## DECISION OF THE PLANNING ADMINISTRATOR

**PHASED SUBDIVISION TENTATIVE PLAN / CLASS 2 ADJUSTMENT CASE  
NO.: SUB-ADJ24-02**

**SUMMARY:** Proposed phased subdivision tentative plan to divide approximately 21.55 acres into 100 lots with associated site improvements.

# Street Tree Exhibit

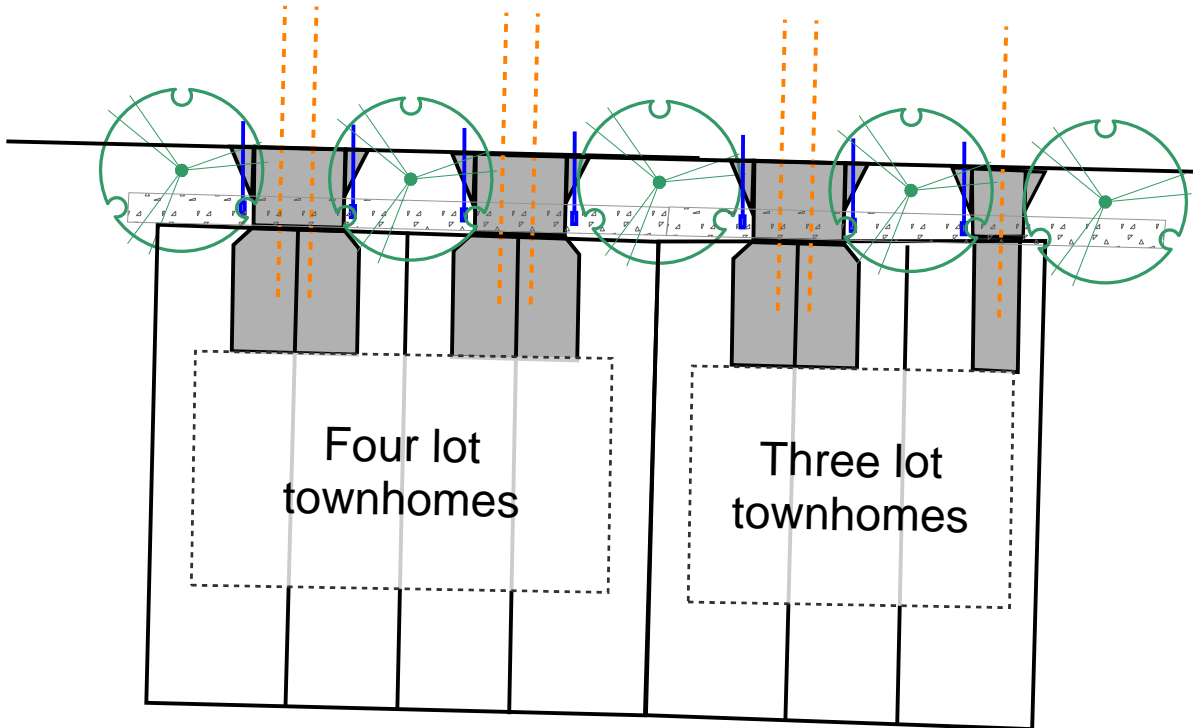
**Condition 26:** Every two attached townhouses shall share a 16-foot-wide driveway approach; where the number of townhouses attached in a row result in one townhouse without a shared driveway approach, the driveway approach to that townhouse shall be limited to a maximum width of 12 feet.

**Condition 27:** Prior to final plat approval of Phase 1, the applicant shall modify the utility plan for Phase 1 to place sewer laterals under shared townhouse driveway approaches and place water meters adjoining either side of the driveway approach.

Water meters adjacent to each side of the approach
